Updated black link configuration figure in 154.6

Peter Stassar, Huawei

IEEE P802.3cw Task Force, Ad Hoc call, 21 December 2020

Figure 154–3—Example configuration of the black link approach

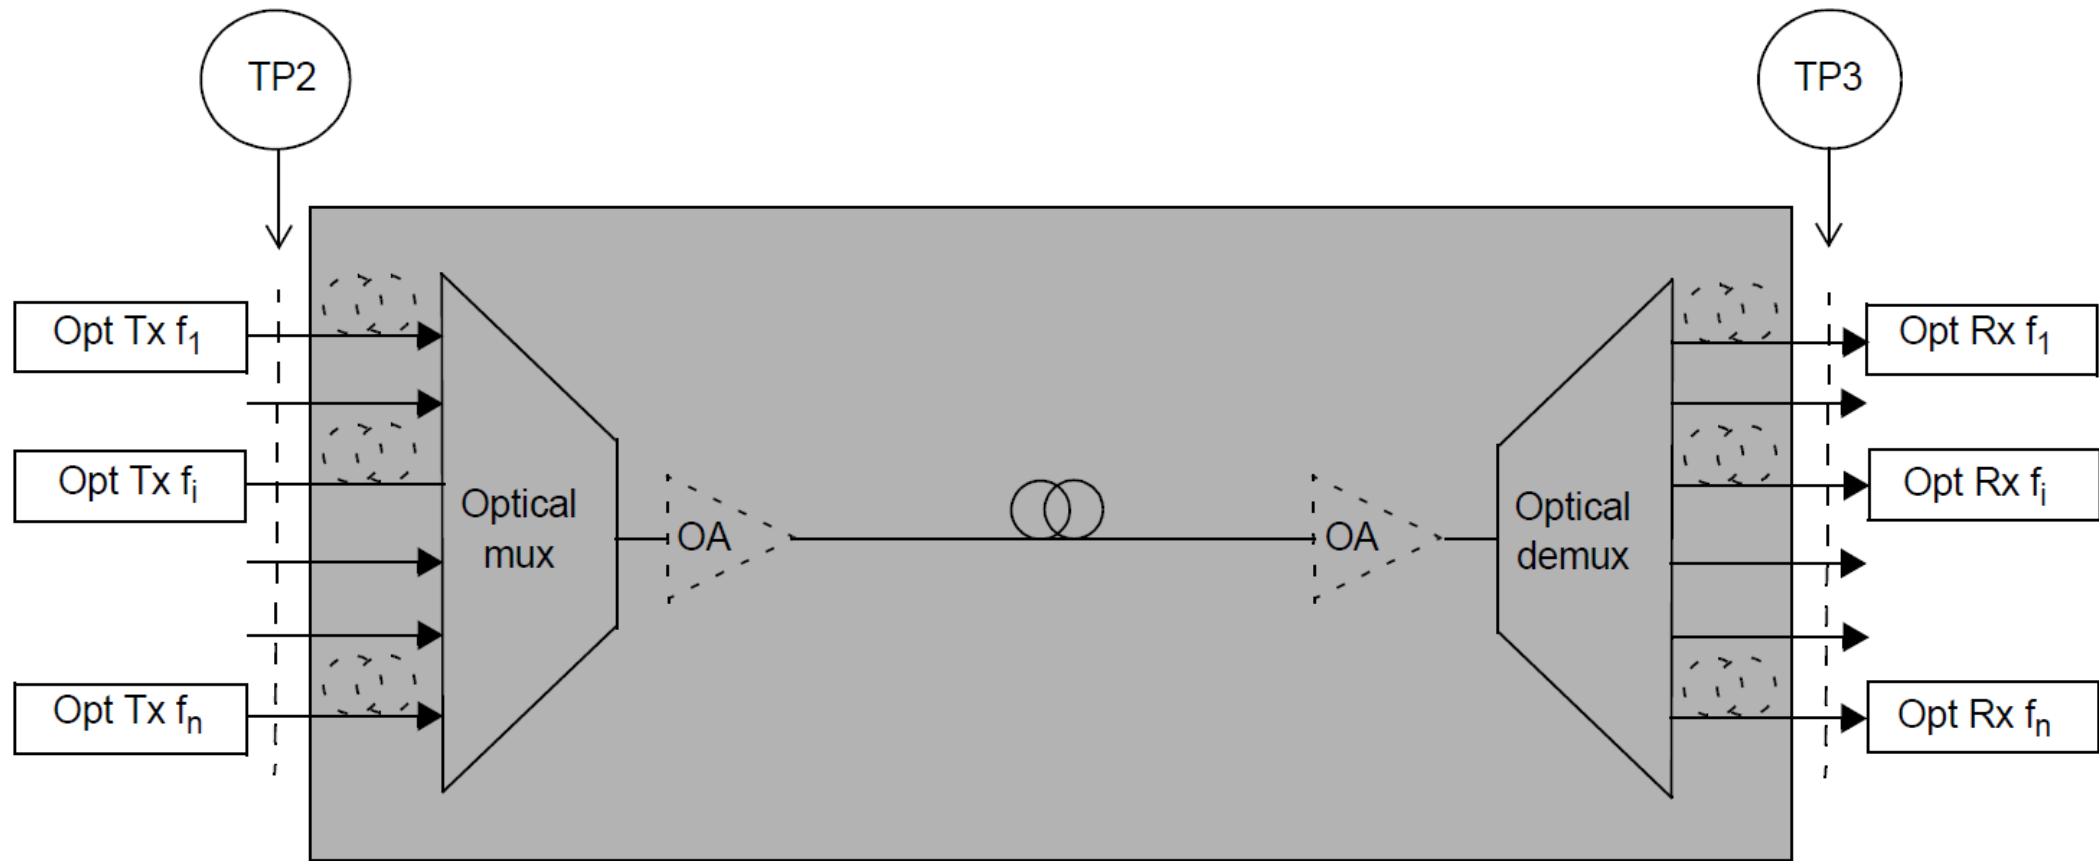
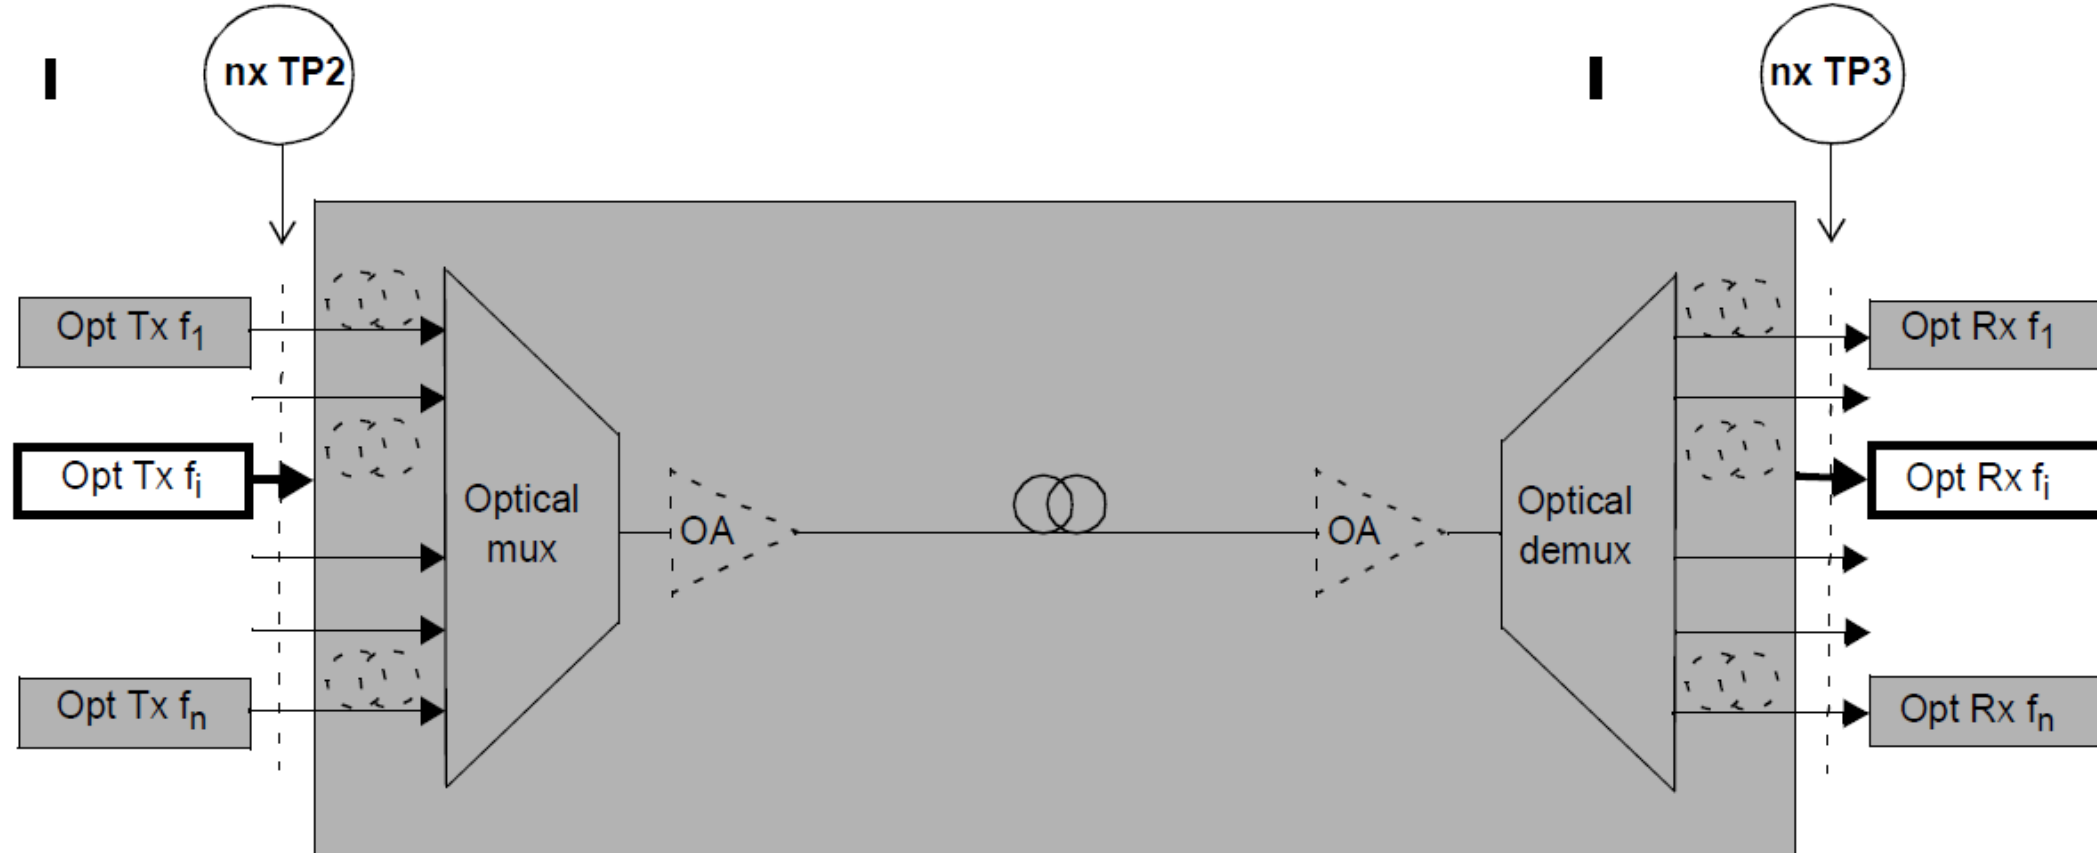
Current figure 154-3 in 154.6

Draft revised figure 154-3 in 154.6

Figure 154–3—Black link example configuration for specifying n DWDM channels
